ONE SYDNEY HARBOUR

BARANGAROO

R4A SUPPLEMENTARY DESIGN STATEMENT

June 2019

R4A Plate Changes Diagram

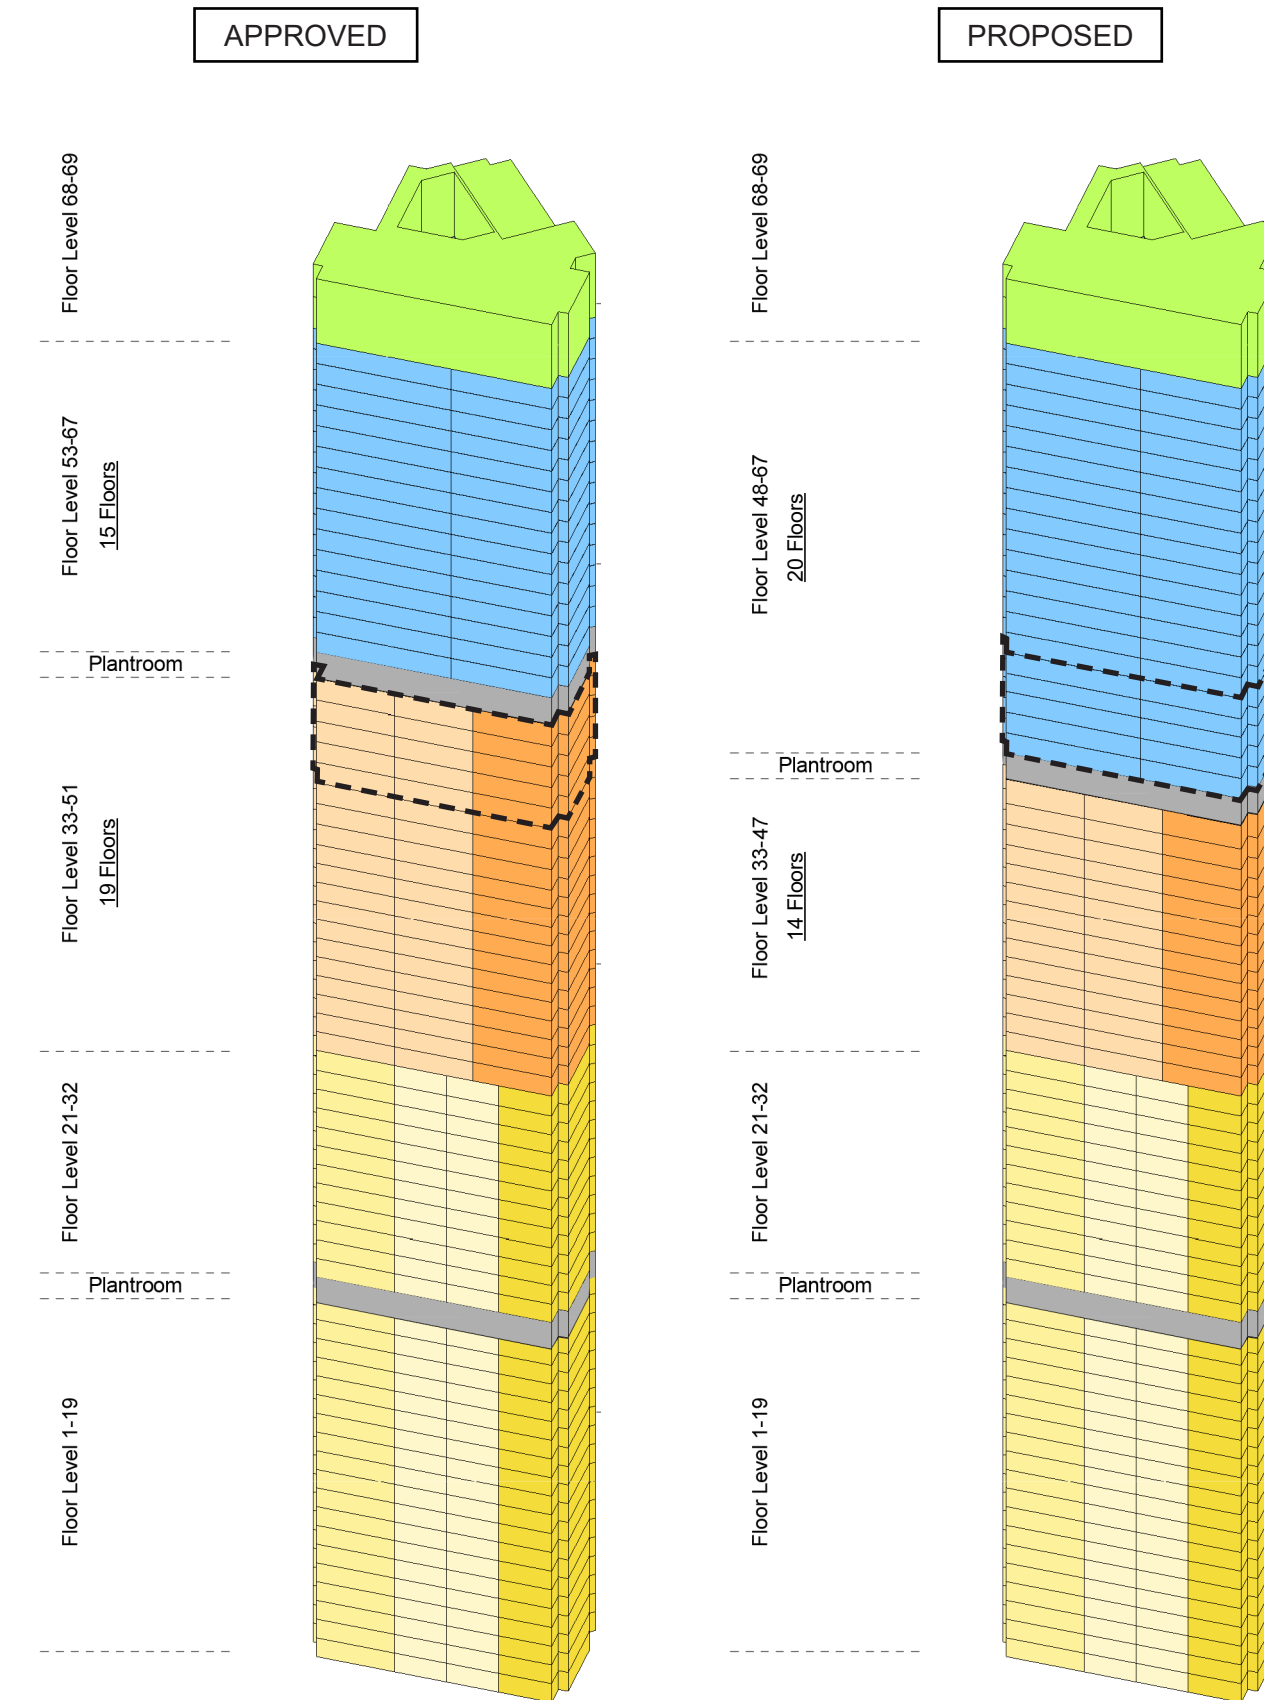
Upper Plate	
Previous:	15
Proposed:	20
Increase:	+5

Mid Plate	
Previous:	19
Proposed:	14
Reduction:	-5

Lower Plate	
Previous:	31
Proposed:	31
No Change:	=

The upper levels of the tower (47-52) have been re-aligned to match the heights of the associated levels of the neighbouring R4B tower. In doing so, the alignment of the finish floor levels and curtainwall modules on both building has been achieved.

The upper level plantroom of R4A has been lowered from level 52 to level 47 in order to allow for an increase in the number of upper floor plate apartments. This increases the number of larger family-orientated apartments in accordance with market demand.

R4A and R4B Alignments Diagram

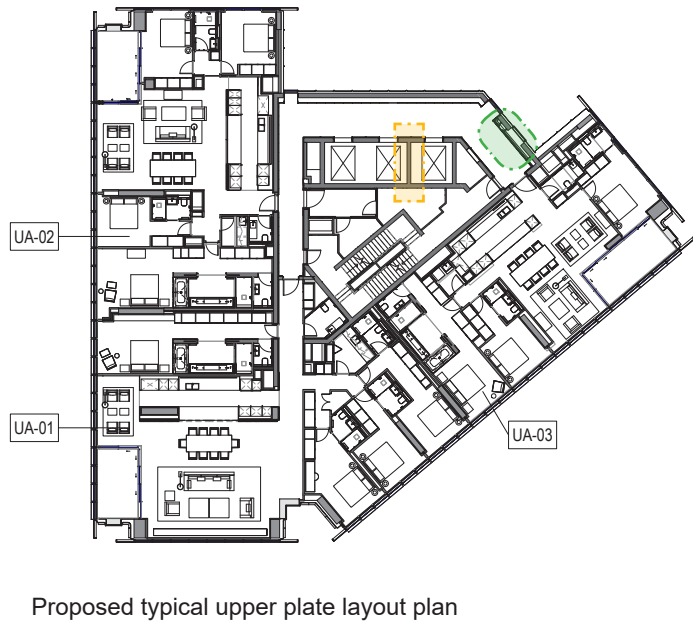
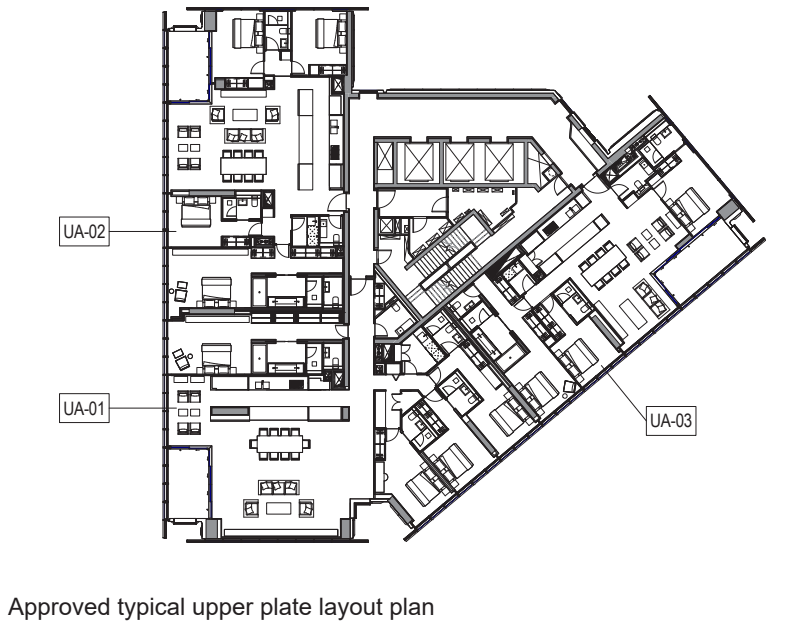
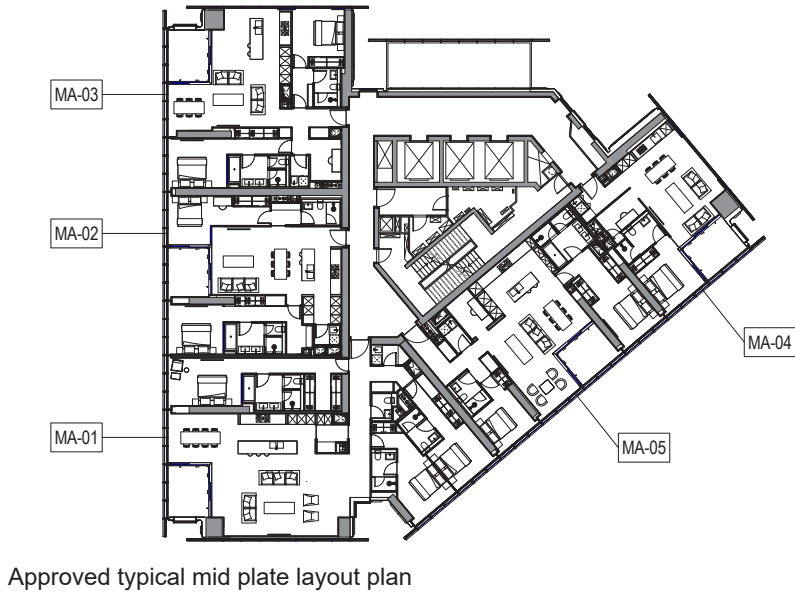
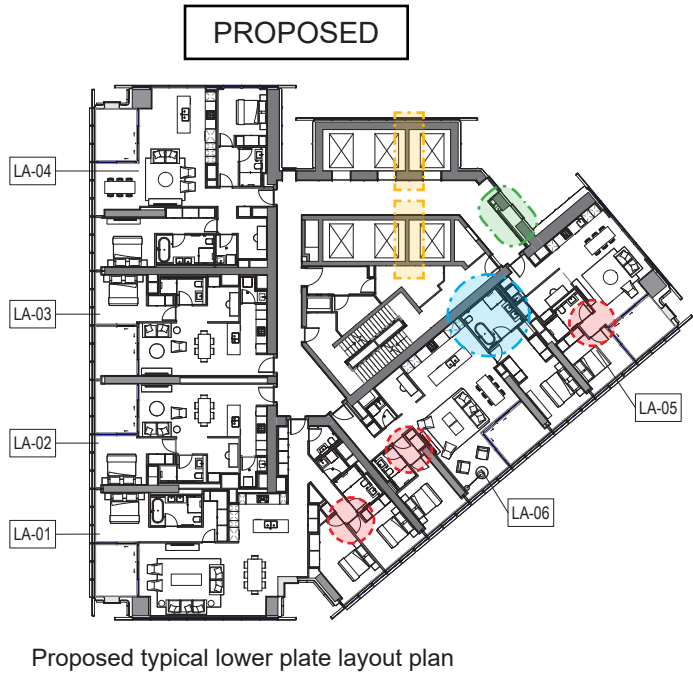
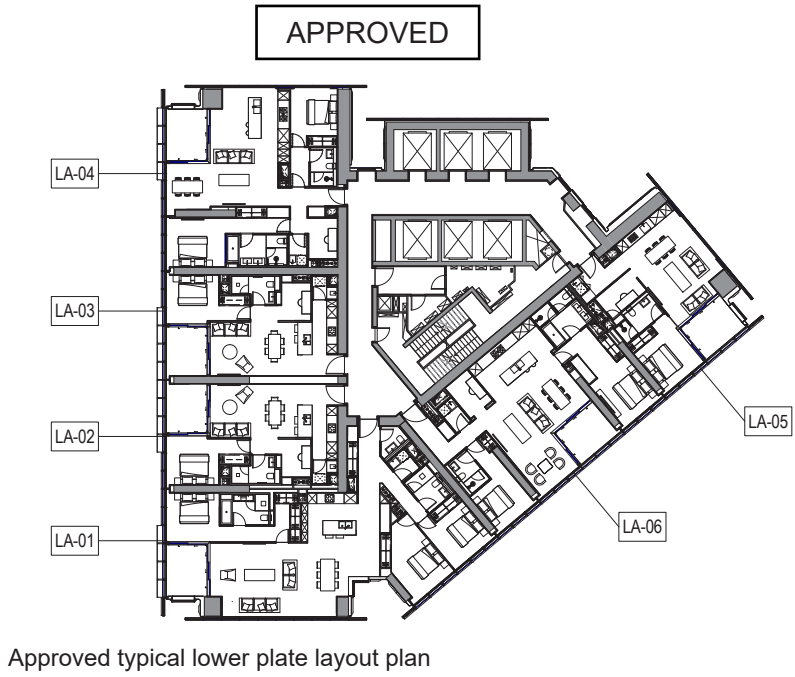
Please note that this adjustment is to happen simultaneously with proposed amendments in the R4B tower which would see the two buildings share an aligned upper level plantroom. The proposed change can be appreciated in the diagrams below.

Approved lower penthouse layout plan - Level 68

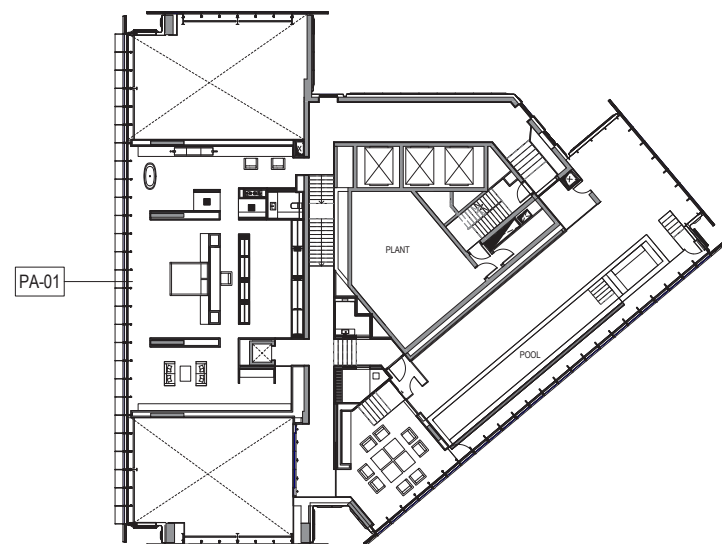
- Reduction of the double height Wintergarden in the North-West corner and an increase in internal area (double height maintained).
- Reduction of the raised pool deck area. In the updated proposed layout, the deck is set back from the South facade and constrained to the areas around the Pool.
- Changes in the Penthouse private lift lobby, with the addition of a dedicated, secondary lift.

Proposed stack joint type unification on main facade

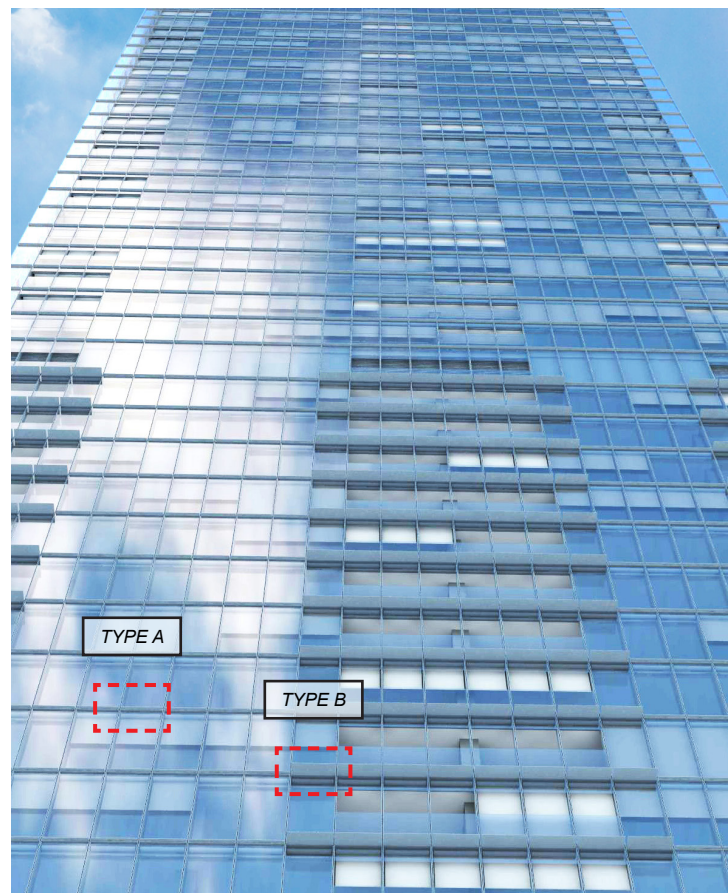
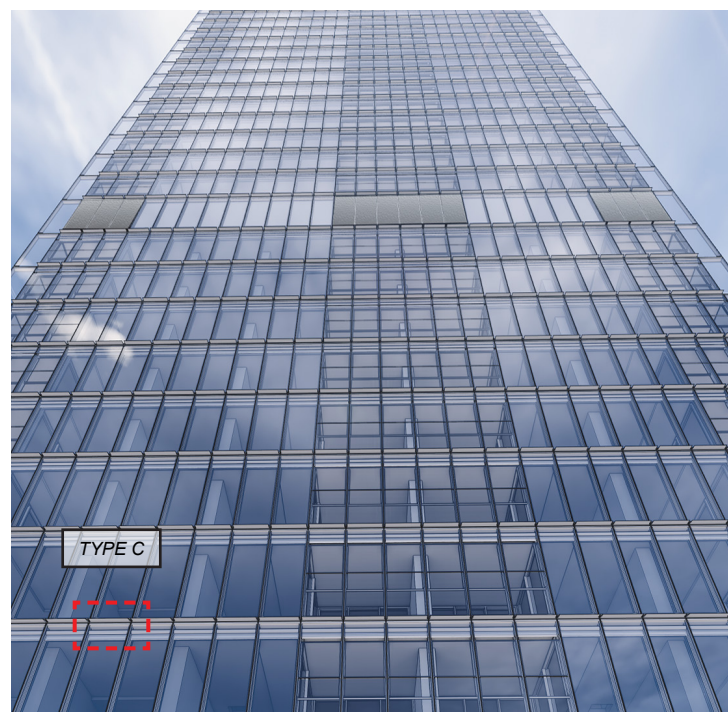
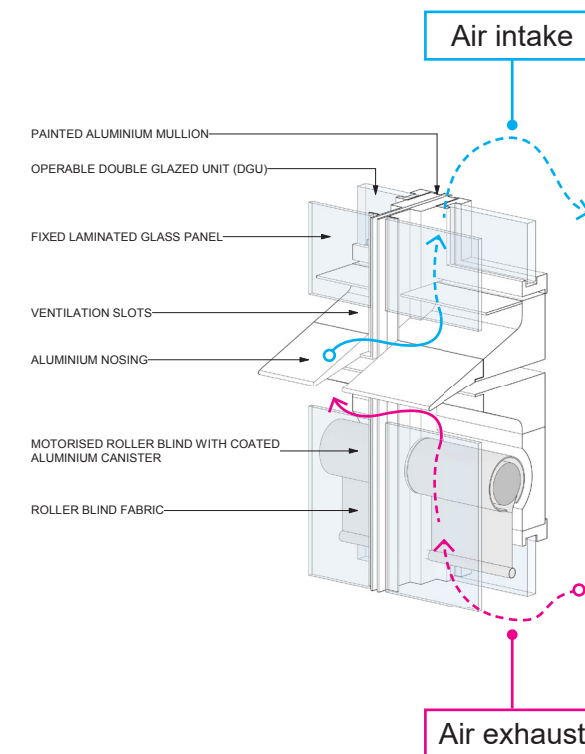
The stack-joint of the open cavity facade has been subtly re-designed as a result of specialist advice from wind consultants. The approved wind deflectors, which are present in only some of the lower floor plate facade panels, are proposed to be removed via this modification and replaced with a single extrusion that achieves favourable performance results across the entire primary facade.

This refinement creates a unified solution for this facade system and in doing so achieves the homogeneous appearance that was originally envisaged for this facade type.

Low Rise West Elevation - Approved

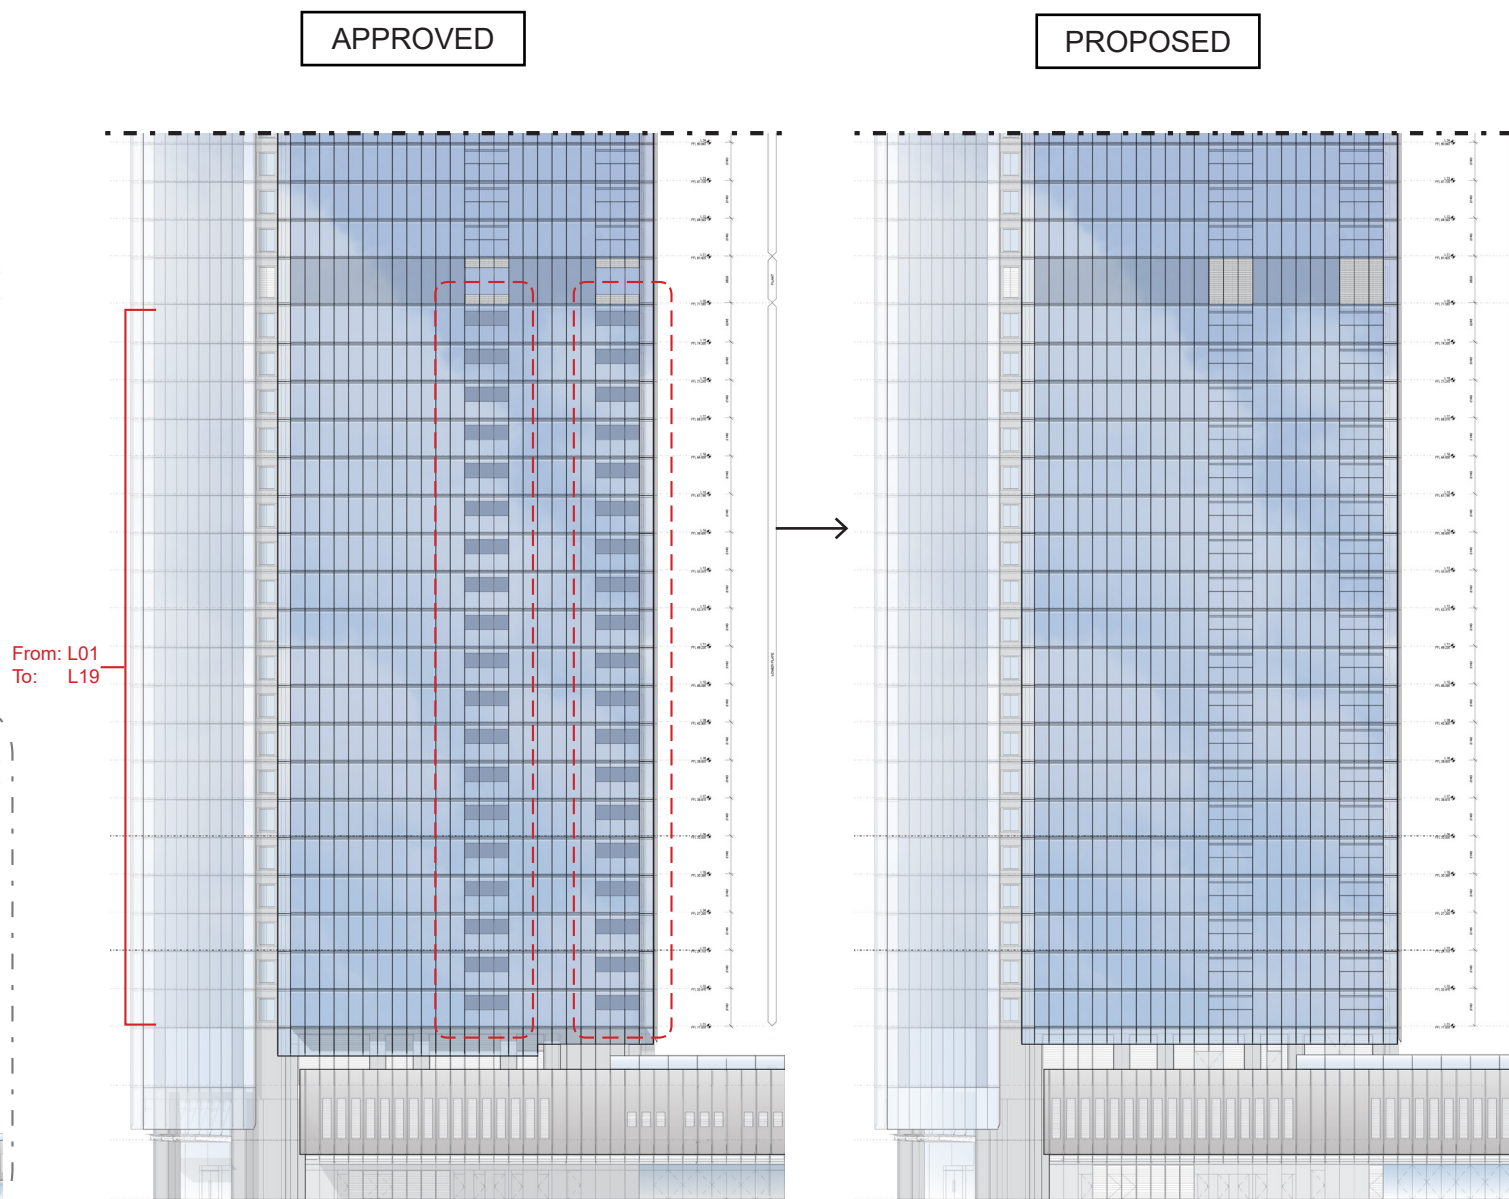
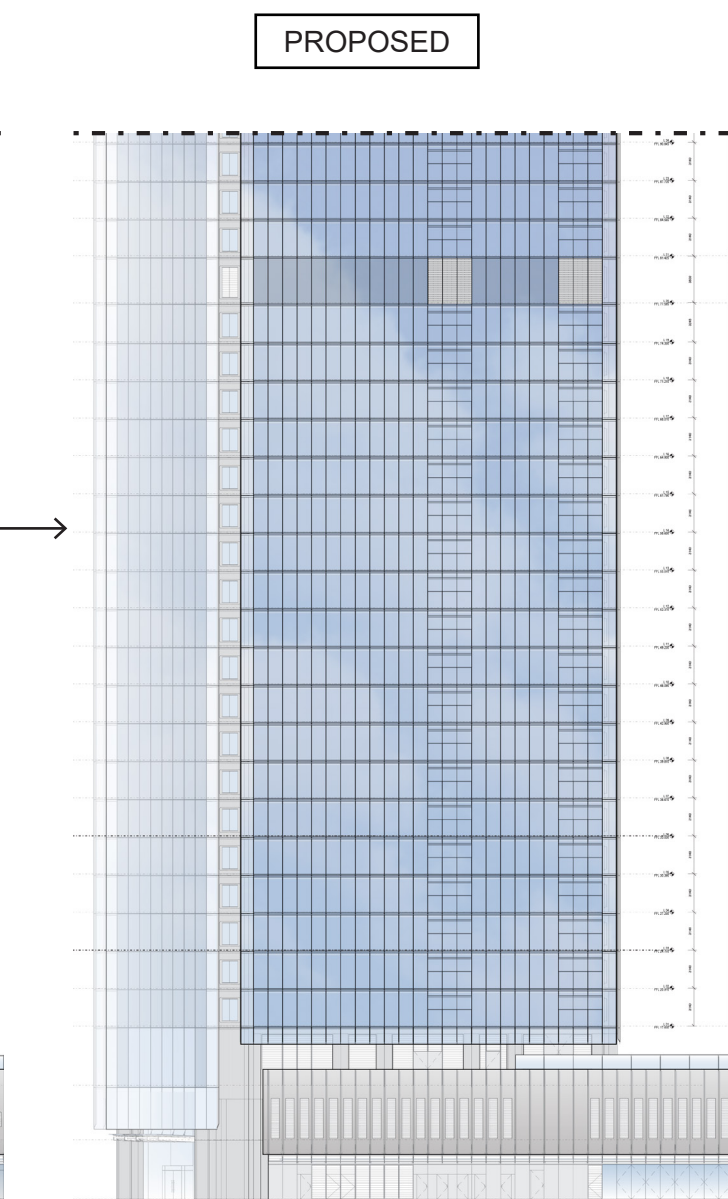
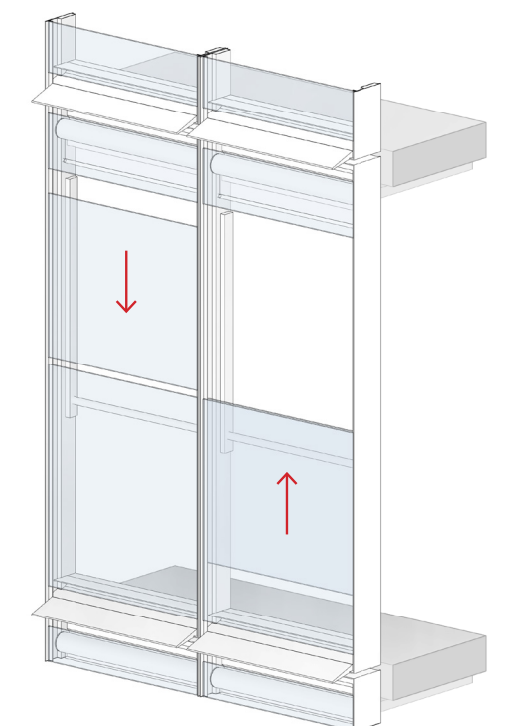
In the approved design, the apartments in the lower plates of the tower (from Level 1 to Level 19) differ from those above when it comes to the balcony facade typology. These lower level balconies have a permanently open facade with a fixed glass balustrade. The apartments above, however, are to be fitted with an operable glass sash window system which can be partially closed to create a wintergarden space. This allows for a greater degree of protection against rain and wind and thus will provide greater amenity for the residents.

Following further wind analysis, and in an effort to create a higher degree of homogeneity in the facade design, it is proposed that this wintergarden sash system is extended across all balconies of the tower, regardless of the floorplate typology. This will ensure that all residents will have the ability to moderate the environmental conditions of their apartment's exterior spaces.
